Subject: Submission against 69 Landis St McDowall Application ref: A006920330

**Submission Against Development Application
A006920330 — Lot 69 Landis Street, McDowall
Development Assessment
Brisbane City Council**

4. Stormwater and Sheet Flow Concerns

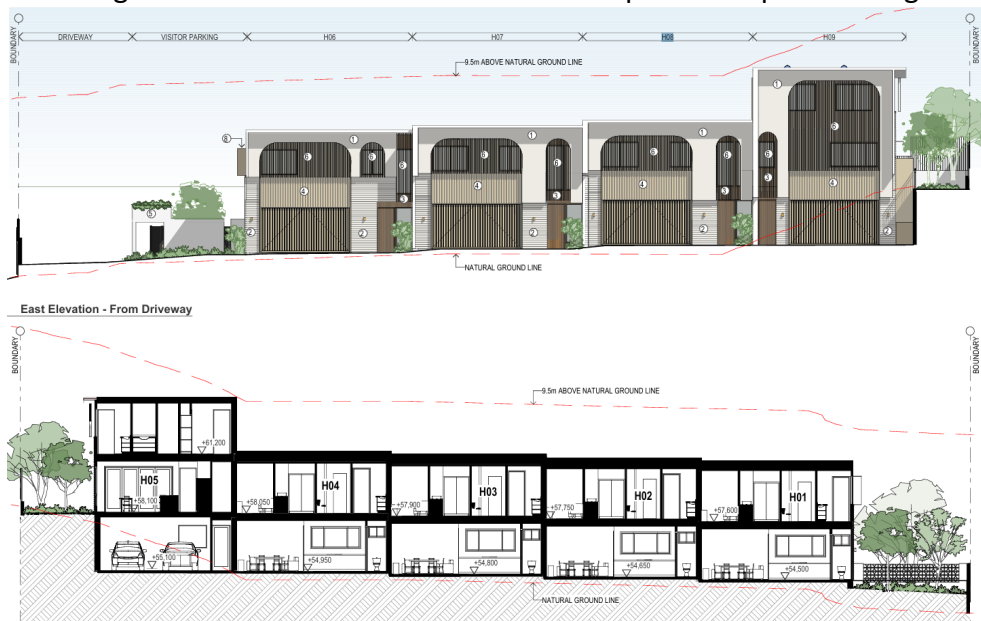
I also have serious concerns regarding stormwater impacts associated with the proposed development.

Over many years, my property has experienced flooding and sheet water runoff issues along this boundary, particularly associated with runoff from this neighboring property 69 Landis Street.

The proposed development substantially increases hard surfaces, paving, roofing, and impermeable areas. I am concerned this will intensify stormwater runoff onto the application documents indicate that parts of the development will sit above natural ground level. Raising the slab height above existing ground levels may redirect or accelerate sheet flow toward [redacted] which is situated [redacted] than the proposed development site.

- a detailed independent stormwater and overland flow assessment;
- confirmation that no worsening of flooding or sheet water runoff will occur to adjoining properties;
- reconsideration of slab levels and finished surface heights; and
- drainage solutions that maintain natural flow paths and protect neighboring lots.
